Z-62
(2015)

APPLICANT: E-Rock Development, LLC

PETITION NO: 2-62

ZONING COMMENTS:

| DATE: 3-24-15 | SCALE: 1" = 2000' |

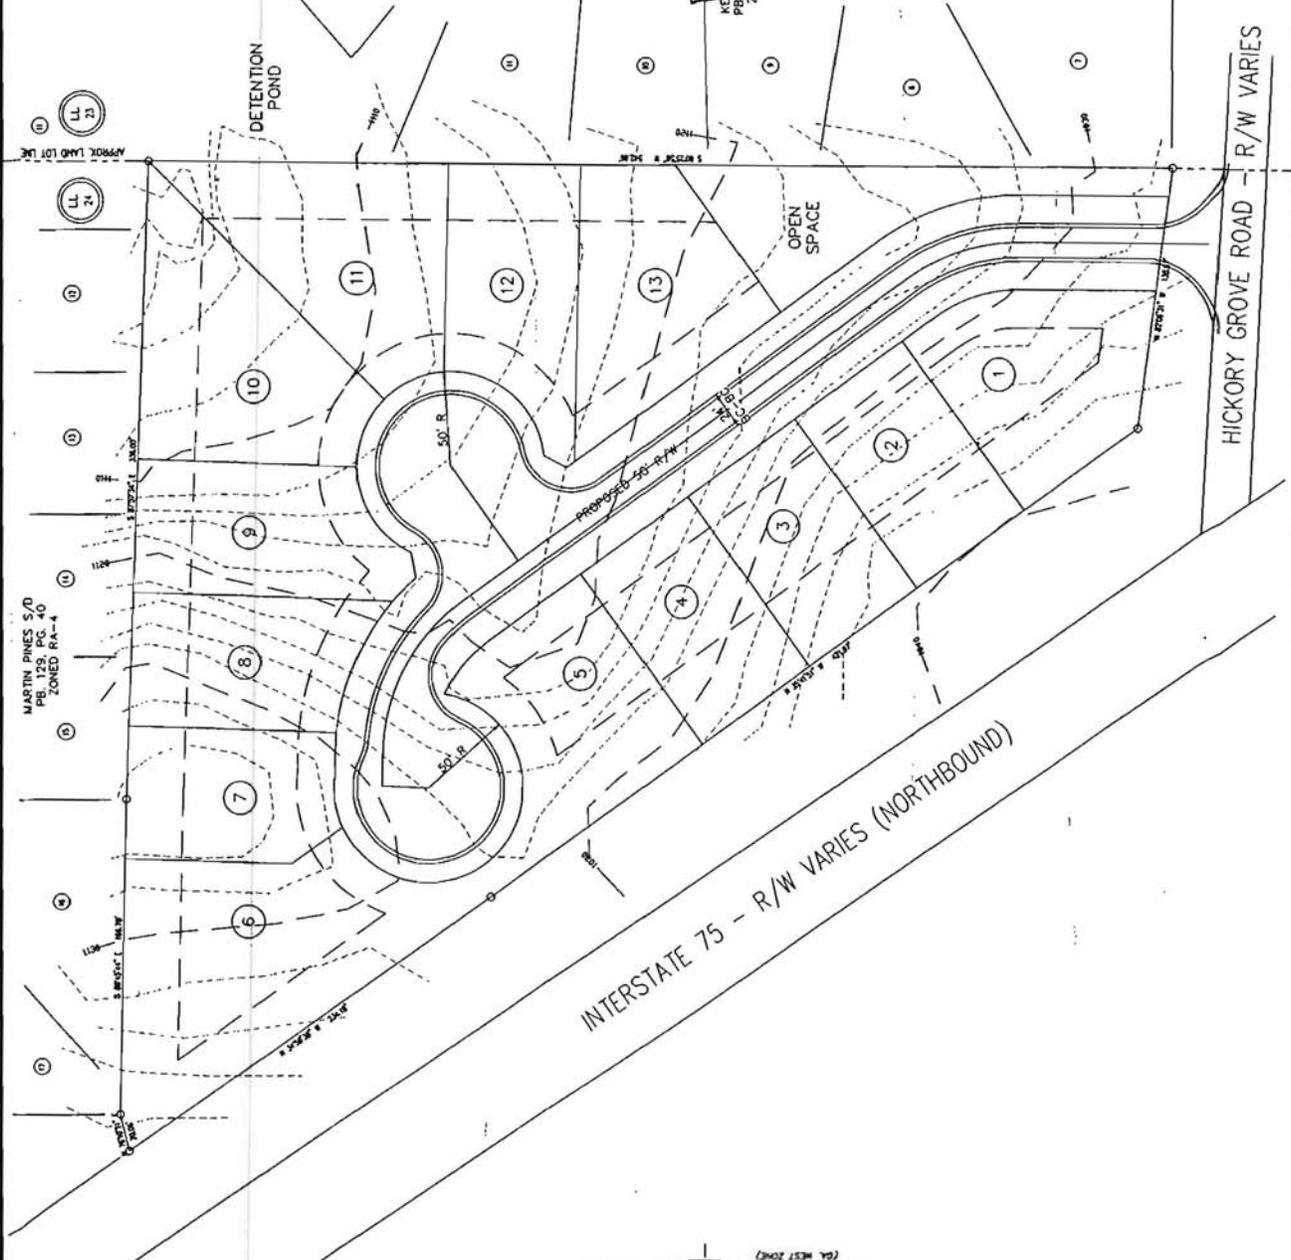
1. Reduce the rear setbacks on lots 6-13 from the required 40 feet to 30 feet.

- No Stormwater controls shown _____
- Copy of survey is not current – Additional comments may be forthcoming when current site conditions are exposed.
- No site improvements showing on exhibit.

1. The majority of the subject parcel drains to the northeast corner into and through an existing drainage easement within Hamby Hills S/D. There is an existing detention within the adjacent Keeneland S/D to the east that already discharges to this existing discharge point. The applicant is proposing to create a combined stormwater management facility that will serve both developments by expanding the existing pond into the rear of Lots 10 & 11. A revised plan will be needed to show the revised layout of those two lots.

Recommend a deceleration lane on Hickory Grove Road for the entrance.

Recommend curb and gutter along both sides and sidewalk along one side of proposed development roadways.
